ADA Curb Ramp New Construction Inspection Form (Blended Transition)

NW. 314TH AVE

24953

NW. COMMERCIAL ST.

1
Corner Position

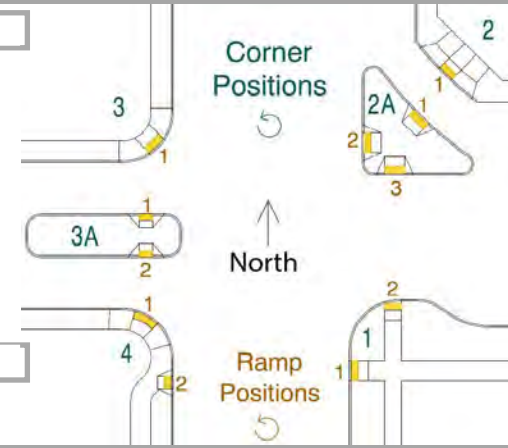
No dome
